# **ORIGINATION FORM** ·

Proposed Revisions to a Standard Plans Index

Date: June 1, 2021 Originator: James McGinnis Phone: (850) 414-4952 Email: james.mcginnis@dot.state.fl.us **Summary of the changes:**  Index Number: 102-661 Sheet Number (s): 1 and 2 of 2 Index Title: Bicycle Lane Closures

S	INDEX	SHEET	
S	102-661	1 of 2

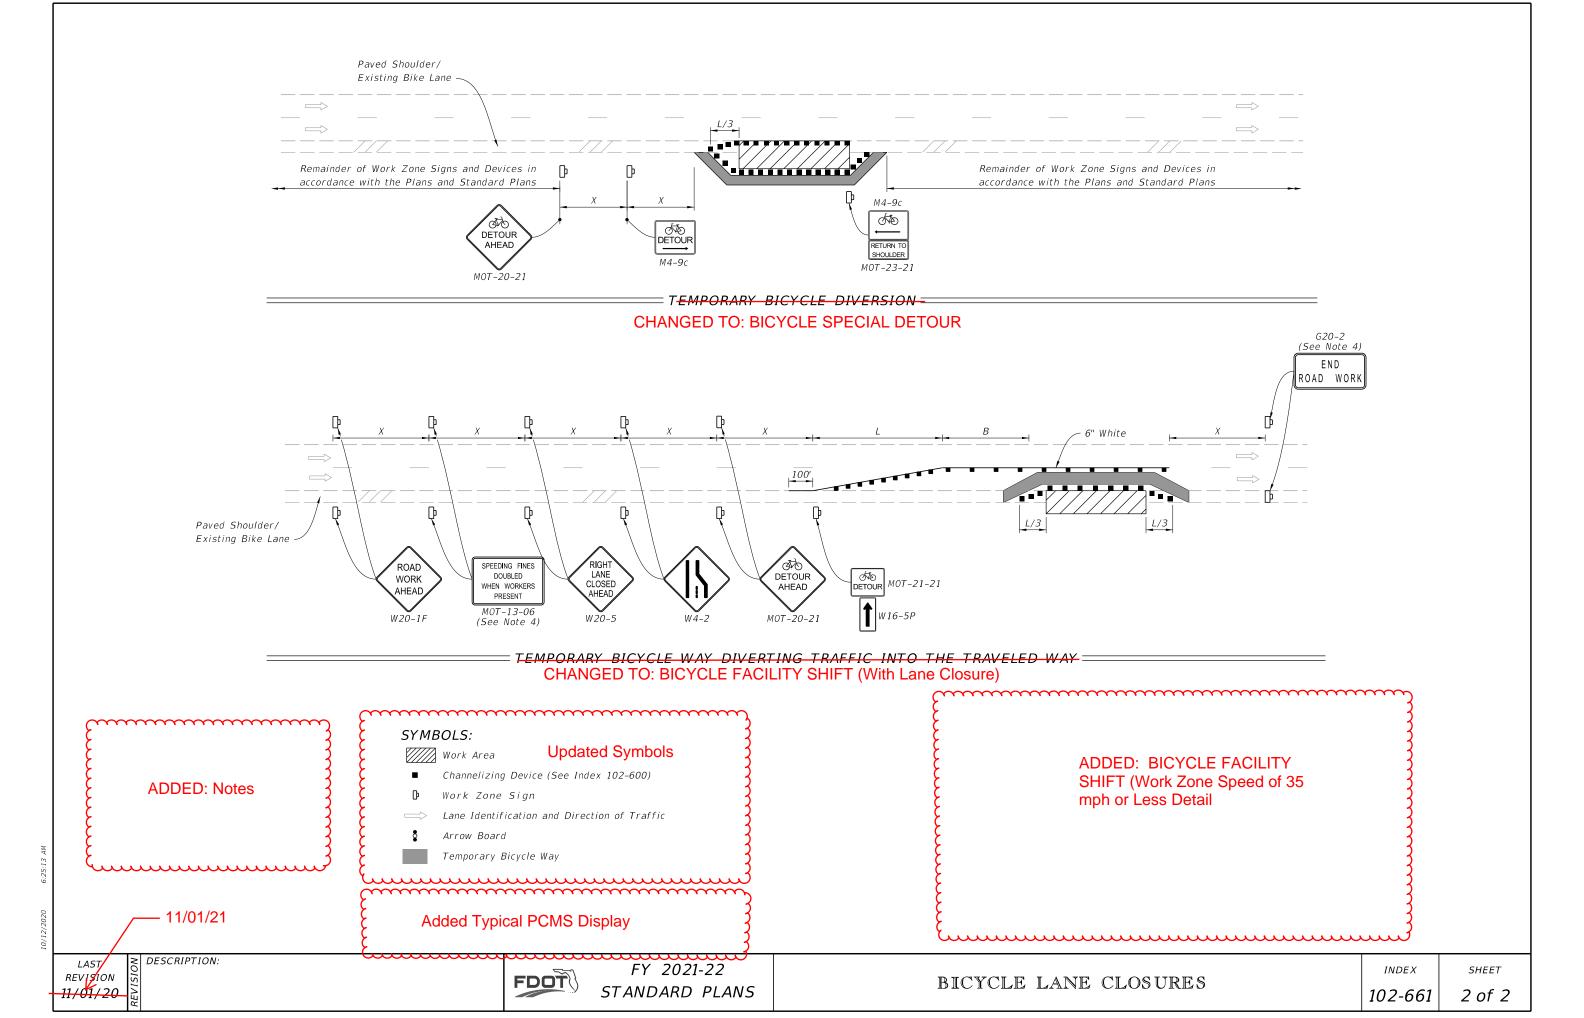
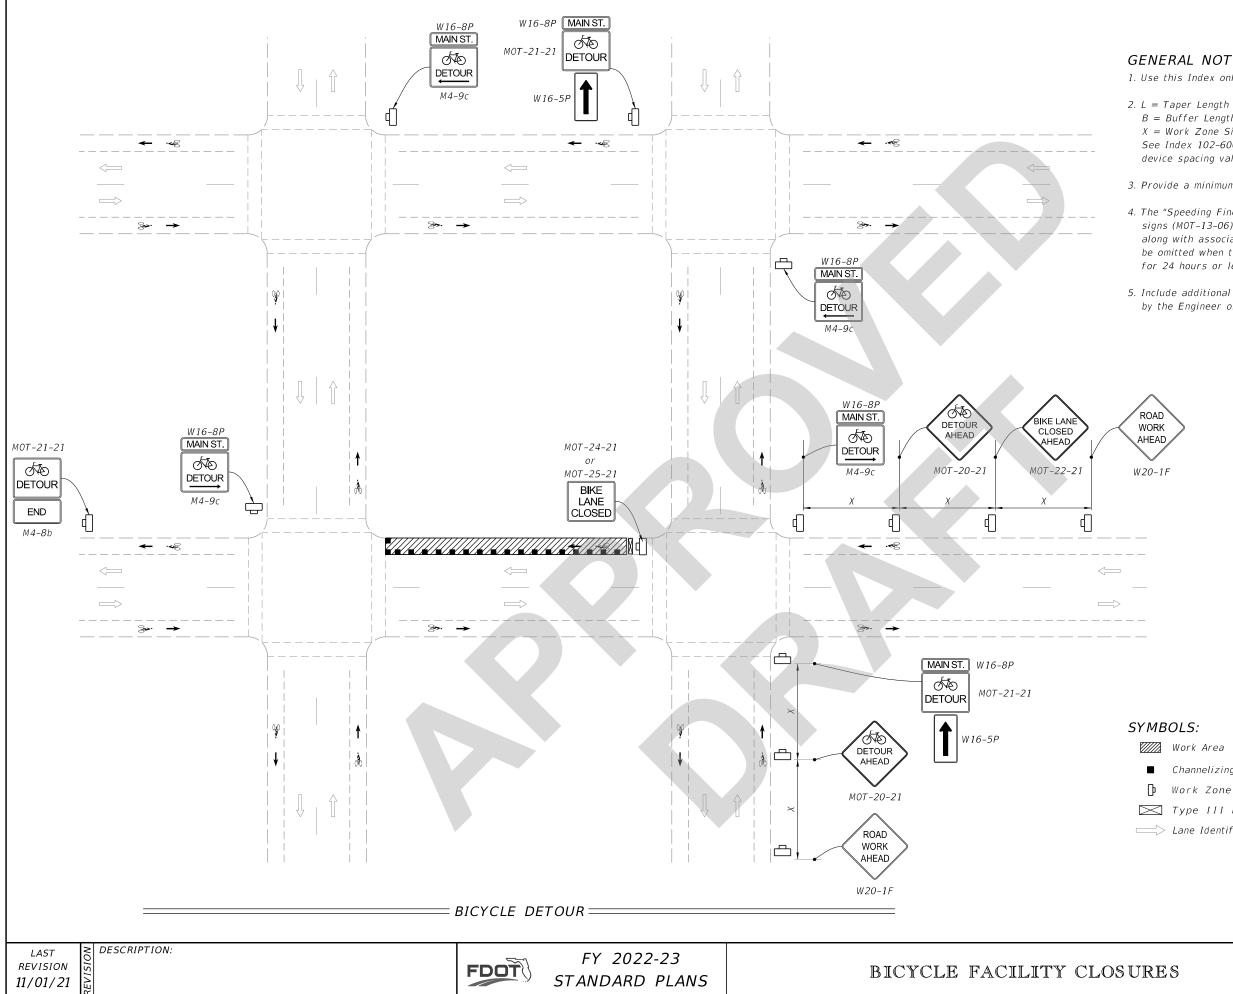
All Sheets: Title Change to " BICYCLE FACILITY CLOSURES"

Sheet 1: Changed Note 4 - "work zone" to "work operation".

The duration provisions of the index are intended to apply to the length time needed to perform the specific temporary traffic control work "operation" shown, which is independent of the duration of an overall construction project. The term "Work Zone" is being replaced with "Work Operation" to clarify the intent.

4. The "Speeding Fines Doubled When Workers Present" signs (MOT-13-06) and "End Road Work" signs (G20-2), along with associated work zone sign distances, may be omitted when the work operation will be in place for 24 hours or less.
